Docket No.: 52-011

AR-07-0924

Southern Nuclear Operating Company
Vogtle Early Site Permit Application
Response to Followup Requests for Additional Information on Environmental Report

Response to Followup RAIs

Land Use Acreage – Field Verified Corridor

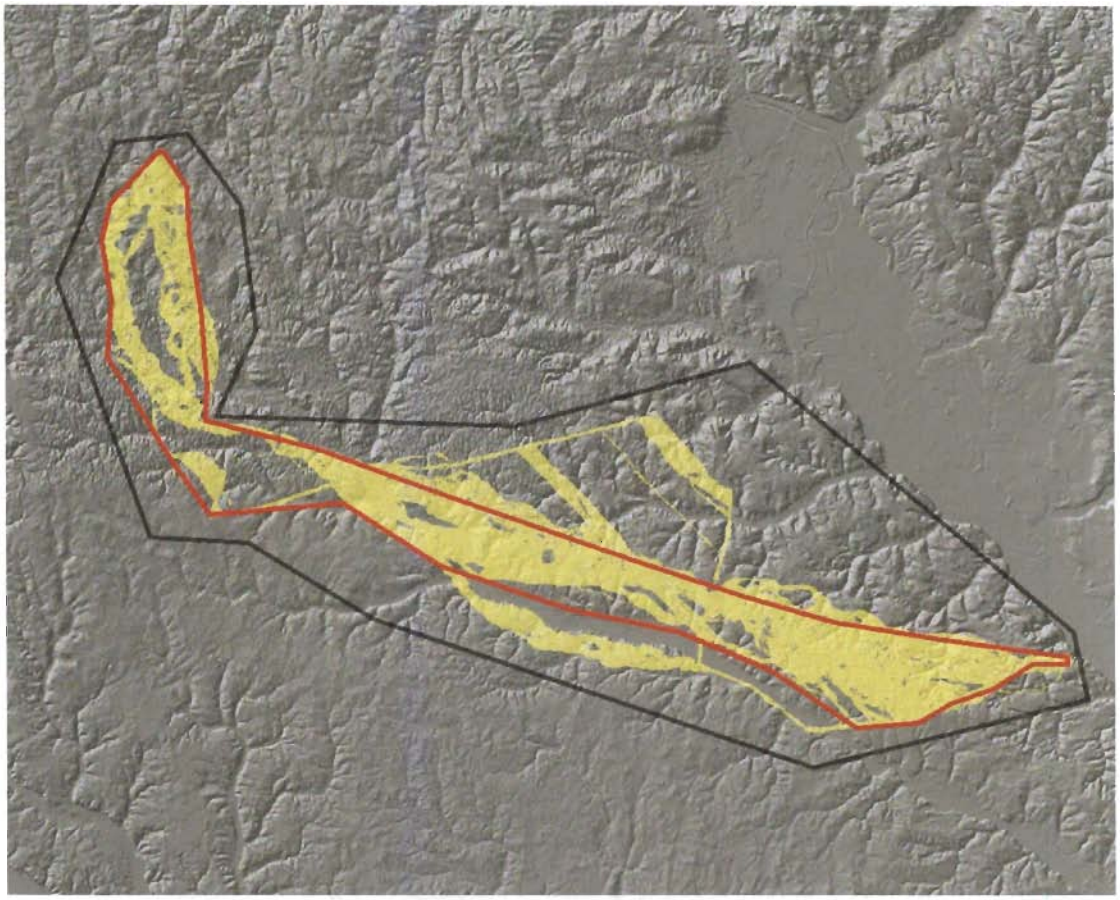
5. Provide the total acreage for the Representative Delineated Corridor. In addition, provide acreage for each of the Land Uses. This information would be similar to the information provided in Table 15 of the Corridor Study, but include the entire Representative Delineated Corridor.

Statistics for the corridors generated from the EPRI Model are included in Table 14 on page 52 of the January 2007 Corridor study, Thomson – Vogtle 500 kV Transmission Project report. Statistics for the representative route (ROW) are included in Table 15 on page 54 of the same report. It is assumed that this request is for the Field Verified Corridor shown below. The statistics for the Field Verified Corridor are provided in the following table.
